**To:** Land Use and Planning Committee      **Date:** 10/2/2017

**From:** Jackie Teed      **File:** REZ00143  
Acting Director of Development  
Services

**Subject:** **34 South Dyke Road: Rezoning to Queensborough Townhouse Districts, Parks Districts and Commercial Waterfront Districts - Preliminary Report**

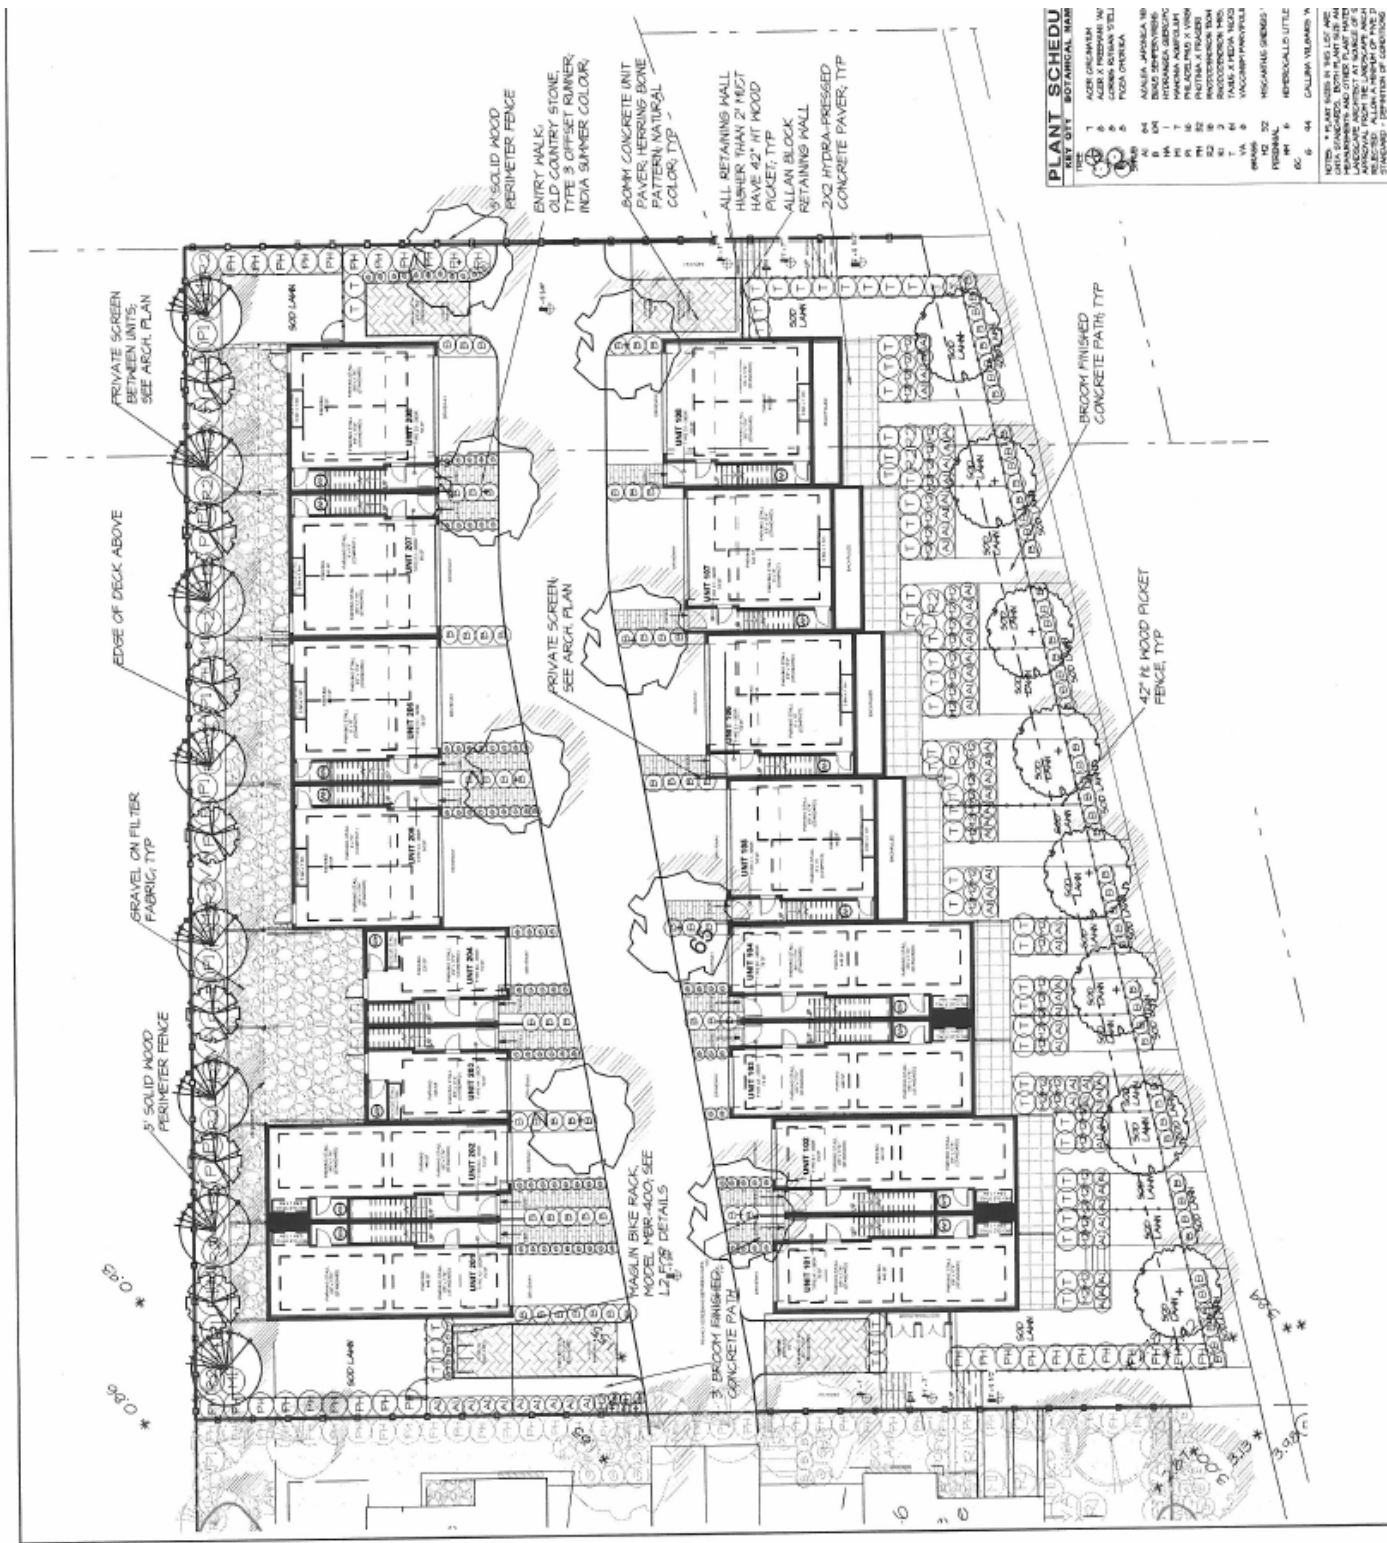
Staff have reviewed the site plan and believe that there is a Flood Plain issue with the proposed design of the north row of buildings. In order to reduce the number of tandem parking spaces in the development the applicant deleted one of the parking spaces for units 203 and 204 leaving them with one parking space each. This would be a possible solution to the high percentage of tandem spaces in the project except where the parking spaces were deleted, a full height void space was created at grade where the second floor of the unit overhangs this space. The space is 25 feet (7.62 metres) deep and 31 feet (9.45 metres) across.

From a flood plain point of view this void space could be easily enclosed, creating either residential floor space or storage space at grade in the flood plain which is not allowed in the Natural Hazard Development Permit Area #1 – Flood Hazard.

In addition the balconies of the units overhang the rear setback by 6 feet (1.83 metres), creating a larger void area. The entire rear setback under the decks is gravel.

The applicant had the same issue in the previous project on the site at 111 Wood Street. At that time, the New Westminster Design Panel rejected a similar arrangement. The Panel approved the design of that project when the units on each were redesigned to cut back on the building and rear deck to allow more sun penetration for the middle units.

Staff consider that the issue of the void areas must be addressed prior to proceeding further and thus recommend as step two in the Process that suitable plans be submitted prior to the application moving forward. The site plan for the project is on the next page.
